**ZONING AMENDMENT  
& SUBDIVISION STAFF REPORT****Date: October 7, 2010****APPLICANT NAME**

Theodore Knights of Columbus Subdivision

**LOCATION**5800 Swedetown Road North  
(North side of Swedetown Road North, 300'± West of U.  
S. Highway 90 West)**CITY COUNCIL  
DISTRICT**

# SITE PLAN

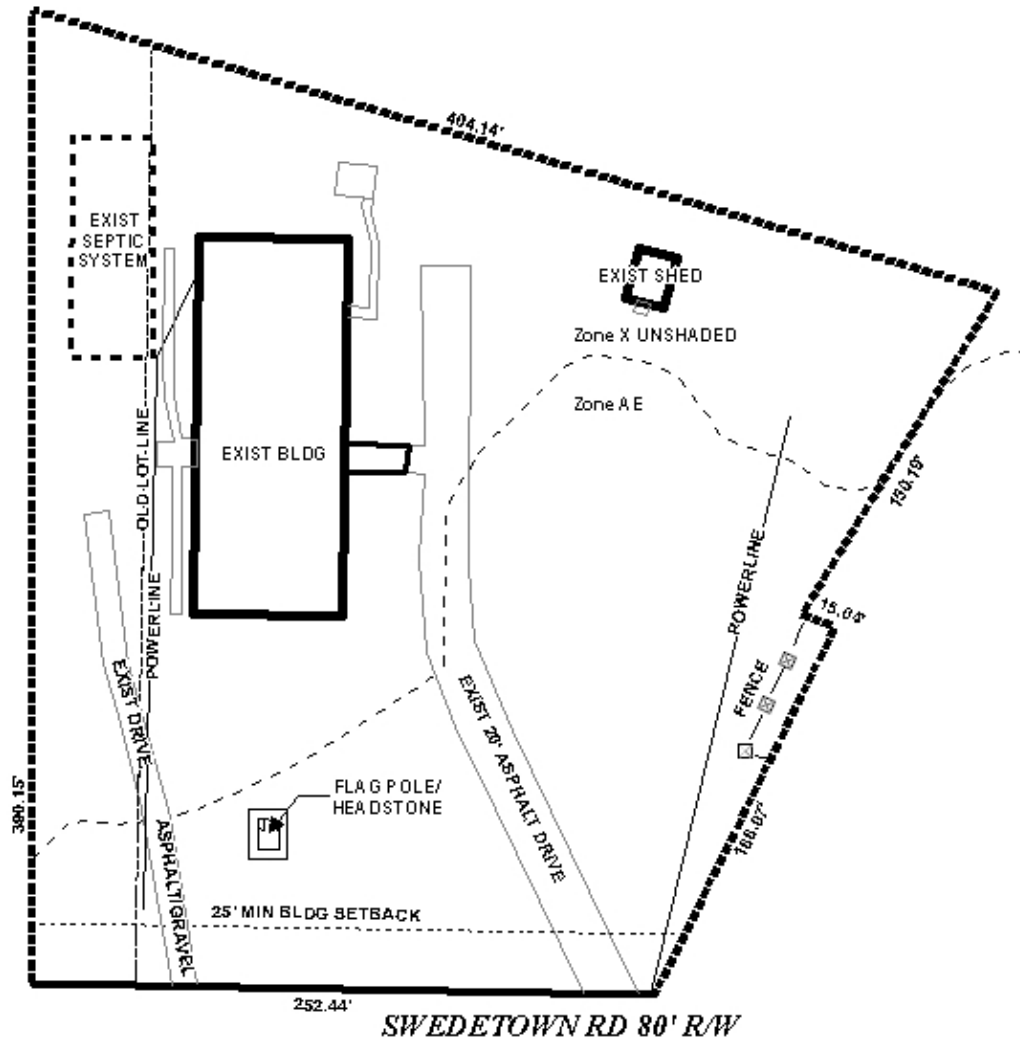
It has been the Commission's policy to require sites to be brought into compliance with the Zoning Ordinance as a condition of a rezoning. The site plan indicates that the site currently does not have any designated parking, and has two driveways, one 20-foot wide asphalt drive and one 10-foot wide asphalt and gravel drive. The westernmost driveway should be removed

and sodded, while the eastern driveway should be widened to city standard, and appropriate parking provided. As the site abuts residentially zoned property, construction of a buffer compliant with Section 64-4.D.1. of the Zoning Ordinance will be required wherever the site abuts residentially zoned or utilized property. Modifications necessary to bring the dumpster into compliance, including screening, setbacks, and required utility connections should be required. Additionally, full compliance with the tree planting and landscaping ordinance should be required.

- 1) removal and sodding of the westernmost driveway on the site;
- 2) modification of the eastern driveway to meet city standards;
- 3) provision of appropriate parking on the site;
- 4) modifications as necessary to bring the dumpster into compliance, including screening, setbacks, and required utility connections;
- 5) provision of a buffer in full compliance with Section 64-4.D.1. of the Zoning Ordinance where the site abuts residentially zoned or utilized property;
- 6) full compliance with the tree planting and landscaping portions of the Zoning Ordinance;
- 7) compliance with Urban Forestry comments: *Preservation status is to be given to the 58" Live Oak Tree located on the North side of Lot 2; any work on or under this tree is to be*
